TECHNICAL REVIEW COMMITTEE (TRC)

September 1, 2026

A. The Enclave @ Lake Geneva Sign Variance, Alternate Keys 1284821, 1699223, 1284511, 3883988, 1771625, 1284503, 1284805, 1771617

B. Fruitland Park Commons Major Site Plan, Alternate Keys 1288151 and 1699665

PROJECT NO.
25245
SCALE
1" = 300'
DATE
August, 2026
SHEET
H-101

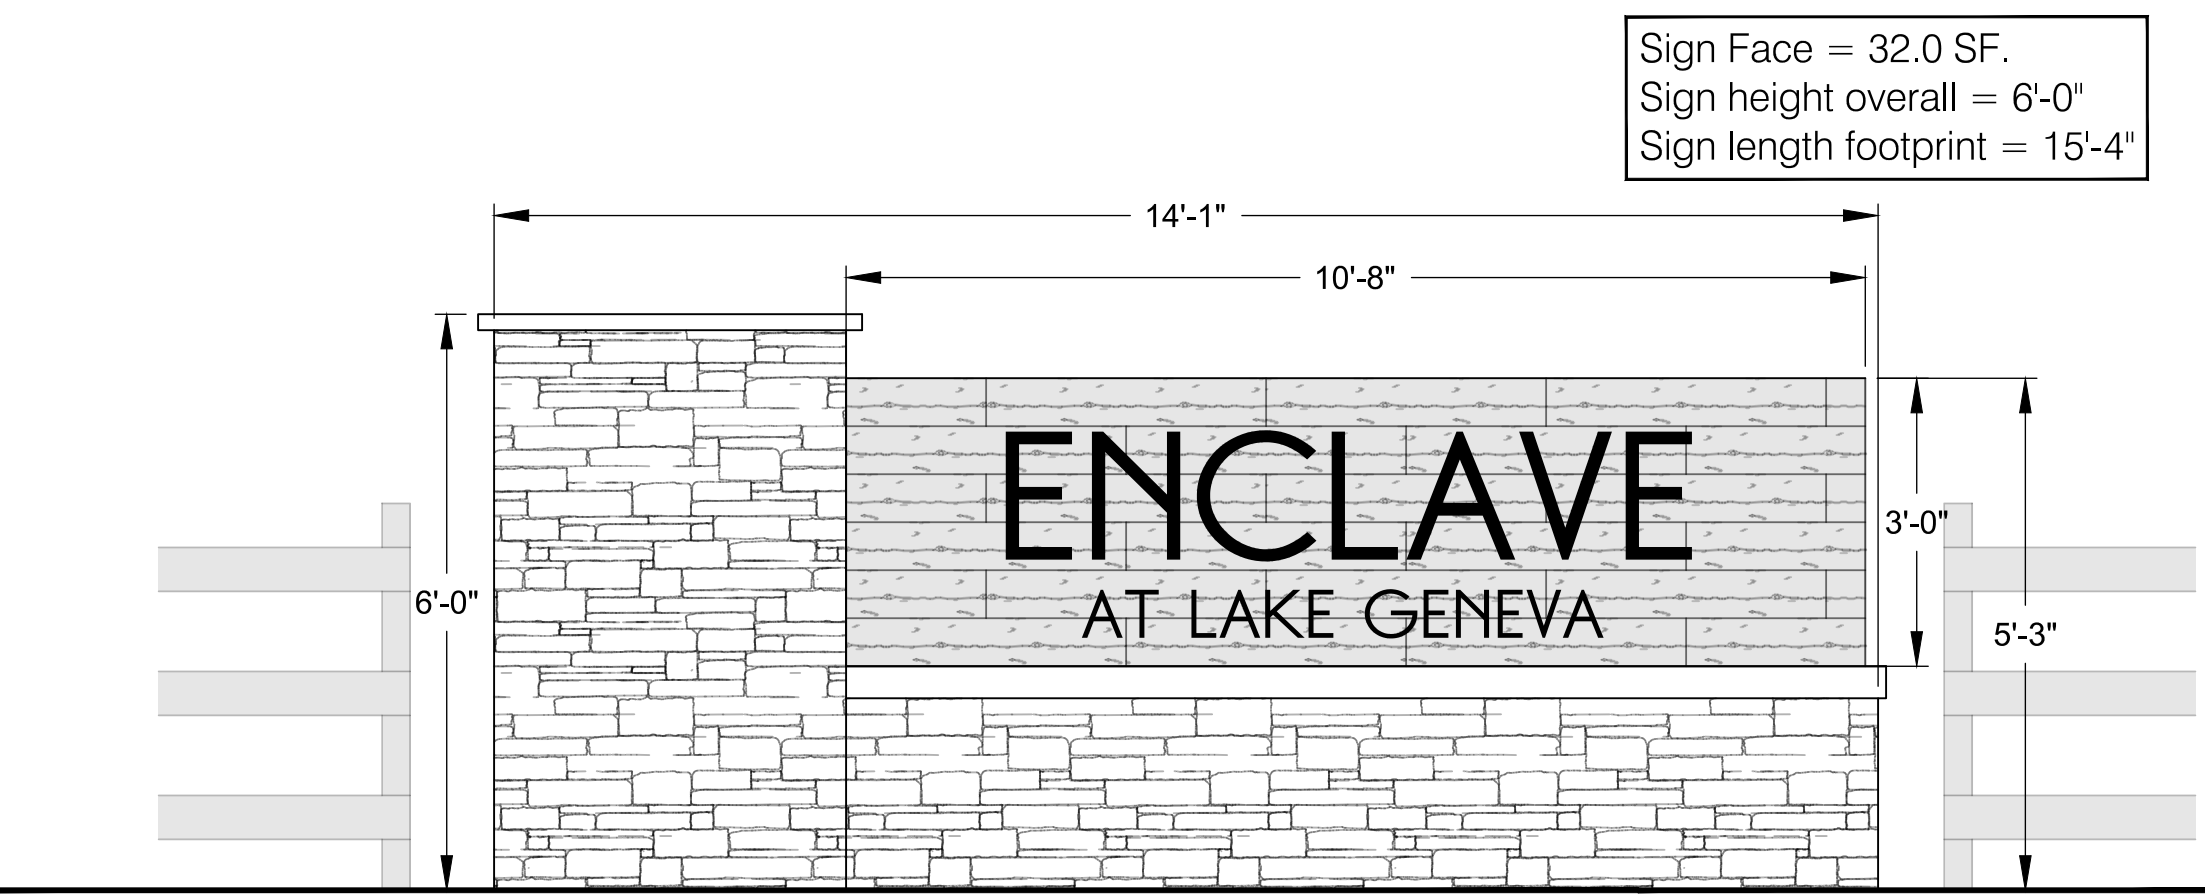
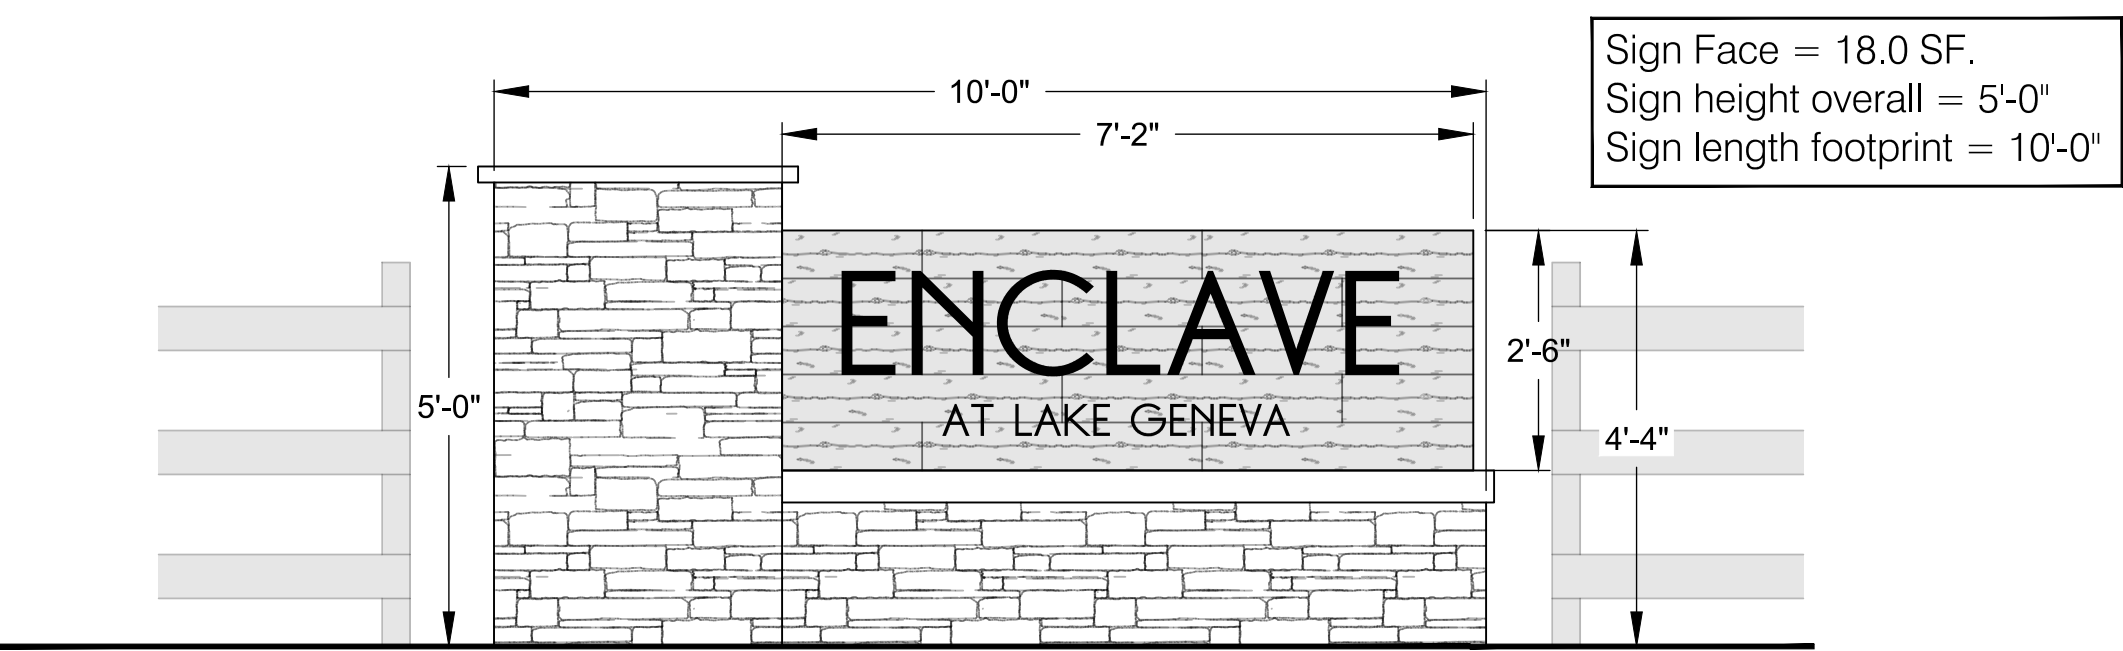
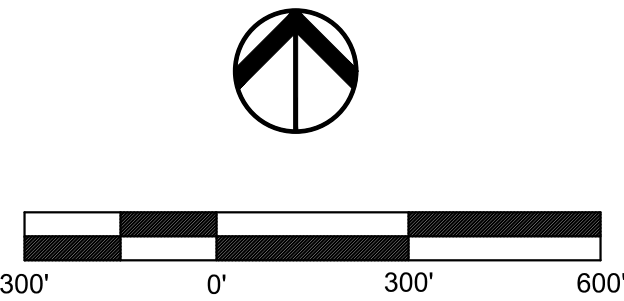
The proposed development has approximately 158' of frontage on Spring Lake Road (alternate key #1284821), and approximately 1,653' of frontage on Lake Ella Road (alt key #'s 1699223, 1284511, and 3883988). The sign regulations allow for one monument sign for each street frontage (Chapter 163, Section 163.070(b)(1)(i)); therefore, the proposed three (3) monument signs meet this criterion. Further, the Master Plan identifies two (2) entrances off of Lake Ella Road at the proposed intersection of Zurich Street and Saint Moritz Drive; and one (1) entrance off of Spring Lake Road at the proposed intersection of Chillon Castle Street. It is unclear if the signs will be illuminated.

Chapter 168, Section 168.010(f) outlines the Review Criteria for variances. The applicant has submitted Justification of Variance; however, it does not address the review criteria as required. The applicant will need to provide justification to include the review criteria.

Please clarify if the signs will be illuminated and submit the justification to address the review criteria.
